FROM: Peter Johansson
 TO: NCITS T10
 DATE: March 21, 1998
 RE: More SBP-2 Revision 3 Comment Resolution

This memorandum addresses the letter ballot comments on SBP-2 Revision 3 not previously resolved by 98-109r2 and SBP-2 Revision 3a. Those two previously published documents concern themselves with editorial issues, only. The technical issues were reserved for separate discussion.

Figure 60 – Fetch agent state machine

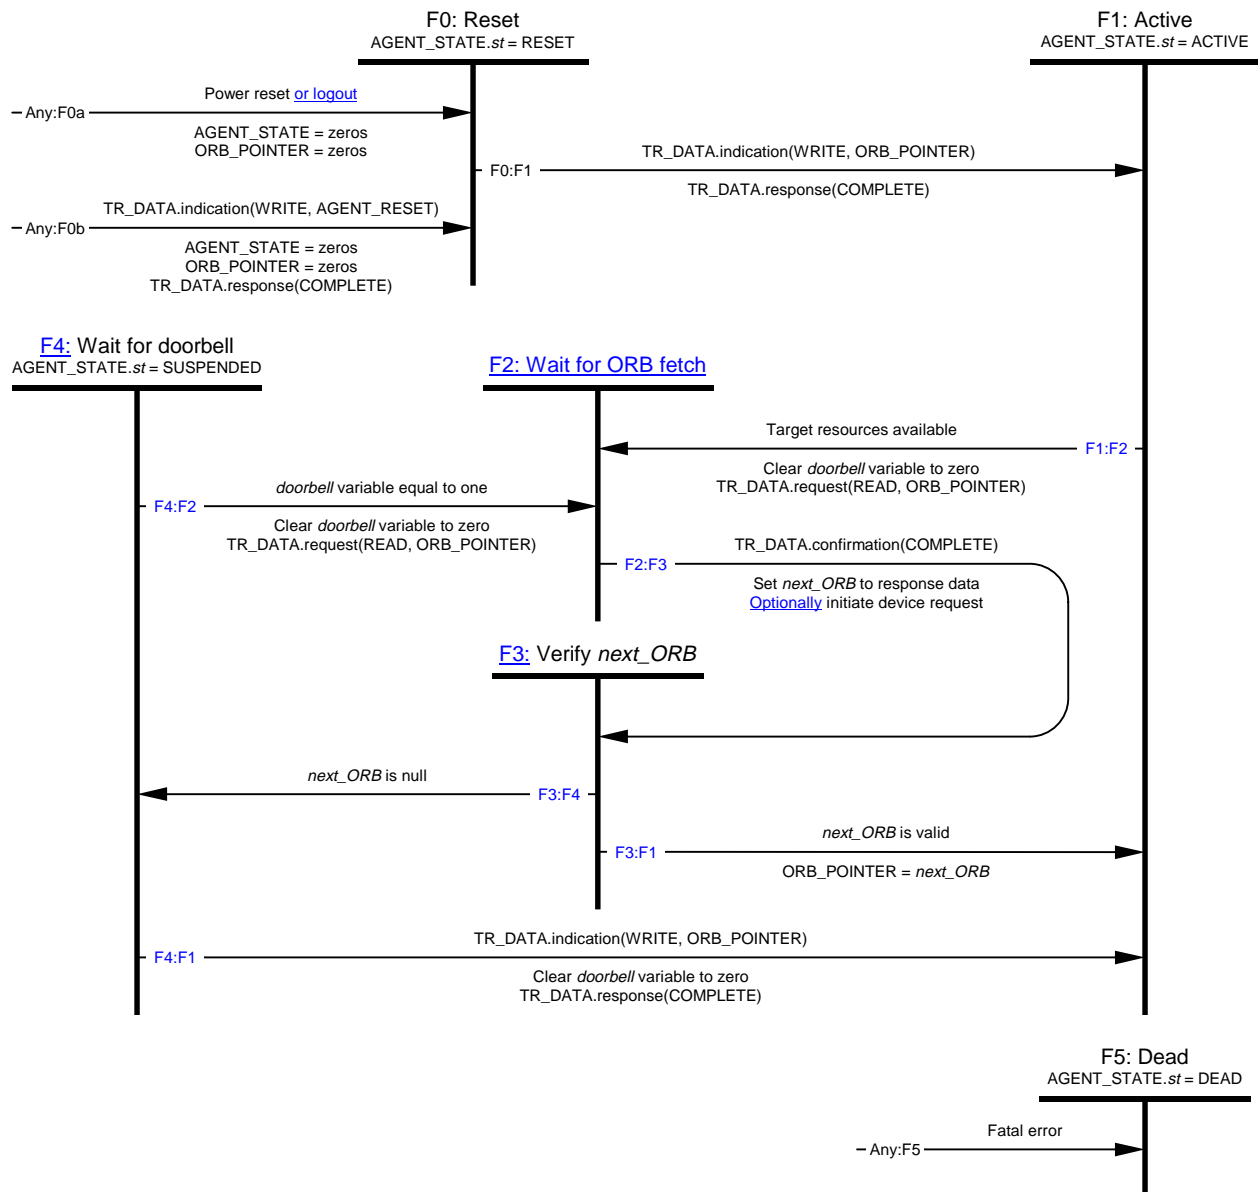
SF 121	Section 9.1.4, Figure 58: add the following changes... ...F0:F1, change the transition condition from "TR_DATA.indication(WRITE, ORB_POINTER)" to "Logged In and TR_DATA.indication(WRITE, ORB_POINTER)"	See 9.1.4 and a redrawn state diagram at the end of this document. The text that precedes Figure 60 makes it clear that <i>all</i> writes to the fetch agent CSR's require the initiator to be logged-in. There's no need to add this extra text to the diagram itself.
SF 122	Section 9.1.4, Text describing transition Any:F0b: Add the following sentence at the end: "If a read request for an ORB is outstanding, the subsequent response (if any) should be accepted but the content of the response should be discarded."	Added " Transaction label(s) for outstanding request subactions shall not be reused until either the corresponding response subaction completes or a split time-out expires; in the former case, the response data shall be discarded. "

SF 123	Section 9.1.4, Text describing transition F0:F1, change in last sentence "with a response of COMPLETE" to "with an <i>ack_complete</i> or an <i>ack_pending</i> followed by a response containing <i>resp_complete</i> ."	In the service model used by IEEE Std 1394-1995, a response is understood to mean either an acknowledgment (other than pending) or a pending acknowledgment followed by a response packet.
SF 124	Section 9.1.4, Text describing transition "F1:F1" to "F1:Fnew".	The changes recommended by SF 124 through SF 127, inclusive, are reflected in 9.1.4 at the end of this document.
SF 125	Section 9.1.4, Text describing transition "F1:F2" to "Fnew:F2".

Reference	Ballot comment	Proposed resolution
SF 126	Section 9.1.4, Text describing transition "F3:F2" to "F3:F1". Delete the phrase ", set the next_ORB variable to the value of the ORB_POINTER register", change "F2" to "F1" and delete the phrase ", from which state an immediate F2:F1 transition follows."	
SF 127	Section 9.1.4, Text describing transition F4:F2, delete the last sentence.	
SF 128	Section 9.1.4, Text describing transition Any:F5, the list of errors gives an indication that only errors associated with the fetching process cause this transition. Add two new bullets "- any device level error" and "- any transport error encountered during the transfer of data or status related to a command being processed that was fetched via this fetch agent."	The errors listed are intended to encompass errors that the fetch agent might directly encounter in its operations. It is also correct that a command error causes the fetch agent to transition to the dead state; see the modified text at the end of this document.

SF 129	Section 9.1.4, Text describing transition F5:Dead, change "AGENT_STATE" to "DOORBELL". The AGENT_STATE register is read only.	Accepted with modifications; see 9.1.4 at the end of this document.
SF 131	Section 9.2, second paragraph, add a new sentence to the end of the paragraph "The target is also responsible for generating the proper system memory address appropriate for the transfer being performed."	There is no way the target can performed the required data transfer functions without generating appropriate system memory addresses. The proposed text doesn't add anything.
SF 132	Section 9.3, related to the last paragraph before the note. We have never included any text to define how to reclaim an ORB that returns a status with the <i>src</i> field equal to one. After this last block is updated with a new ORB pointer value and the doorbell is rung, when can the old ORB be discarded? One way is to monitor the ORB pointer and see if it has changed. This would require polling. Another is to wait until the ORB whose address was placed in the old ORB completes. This could be a long time if a linked list is appended and the device does out of order transactions. I don't have a fixed solution, but we need one.	It could be a very long time, regardless of the execution model! I've added " When src has a value of one, the system memory shall not be reused or deallocated until the target stores completion status for some subsequent ORB in the linked list. ". I've also strengthened the note as follows: "NOTE – For targets that support the ordered model of task execution, the return of completion status for an ORB implicitly indicates that all preceding ORB's in the linked list have completed successfully, are no longer part of the task set and that the initiator may reuse or deallocate their system memory. "

Transition Any:F0a. A power reset shall cause the fetch agent to transition to the RESET state from any other state. The AGENT_STATE and ORB_POINTER registers (that control and make visible the operations of the fetch agent) shall be reset to zeros.

Transition Any:F0b. A quadlet write request by the initiator to the AGENT_RESET register shall cause the fetch agent to transition to state F0 from any other state. The fetch agent shall zero the AGENT_STATE and ORB_POINTER registers before the transition to state F0. Transaction label(s) for outstanding request subactions shall not be reused until either the corresponding response subaction completes or a split time-out expires; in the former case, the response data shall be discarded.

Transition F0:F1. An 8-byte block write of a valid *ORB_offset* to the ORB_POINTER register shall update the register and cause the fetch agent to transition to state F1. The target shall confirm the block write request with a response [subaction](#) of COMPLETE.

Transition F4:F1. If an indication of a write to the ORB_POINTER register is received, the fetch agent shall clear the *doorbell* variable to zero, ~~set the next_ORB variable to the value of the ORB_POINTER register~~ and then confirm the write transaction with a response [subaction](#) of COMPLETE. After the confirmation, the fetch agent shall transition to state F1, ~~from which state an immediate F3:F1 transition follows.~~
